City of Richmond
Urban Development Division

Report to Development Permit Panel

To:	Development Permit Panel	Date:	February 24, 2003
From:	Joe Erceg Manager, Development Applications	File:	DP 97-121069
Re:	Application by MB 628 Ventures Ltd. for a Development Permit at 8580 Cambie Road

That a Development Permit be issued that would allow the construction of two business park buildings at 8580 Cambie Road (on the Odlin Road extension) on a site zoned Business Park Industrial District (I3).

Survey of Existing
Trees

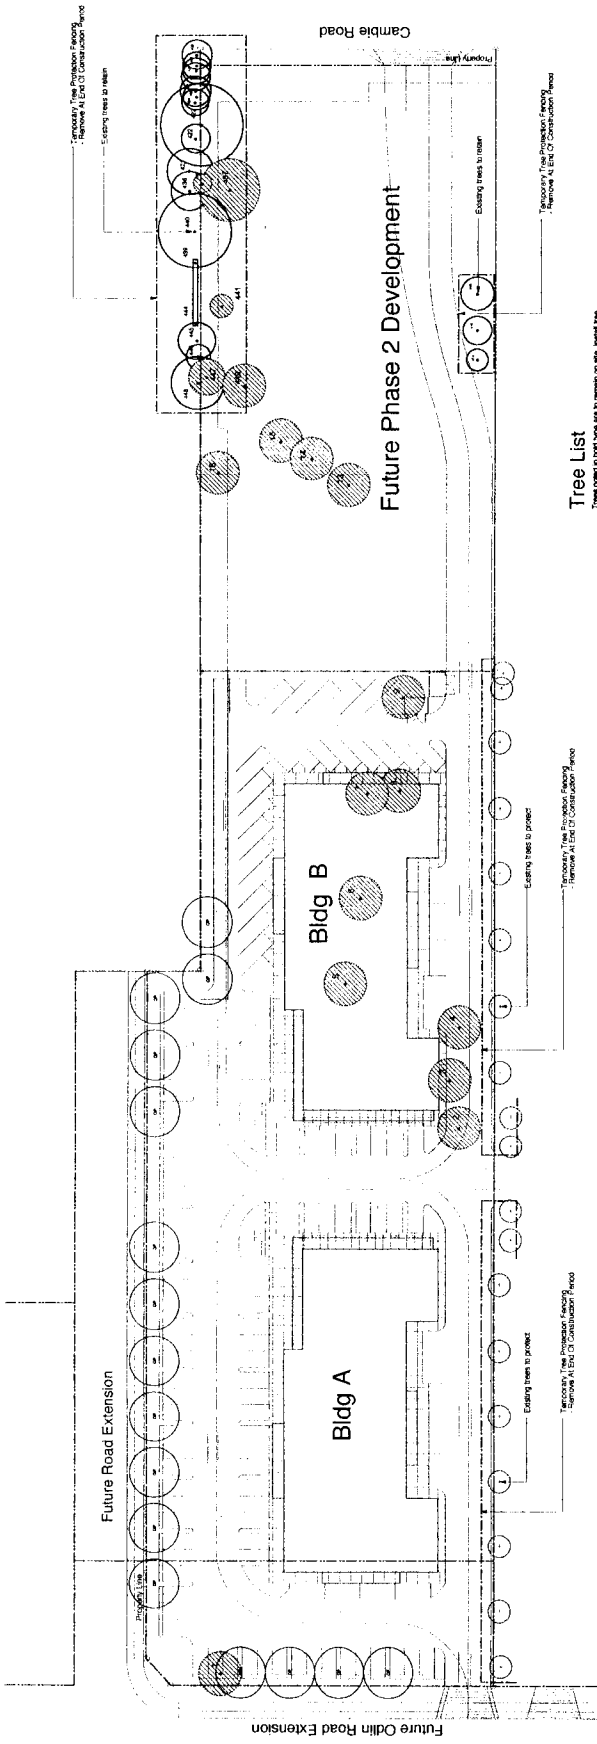
Provide a survey of existing trees and add replacement trees to the landscape plan. See also the Analysis of the City Centre Guidelines. ***The applicants have provided a survey of existing trees on the site, of which there are nine (9) in this phase, mainly fruit trees and smaller deciduous trees. The landscape plan indicates all of these trees being removed and replaced with 10 cm caliper trees.***
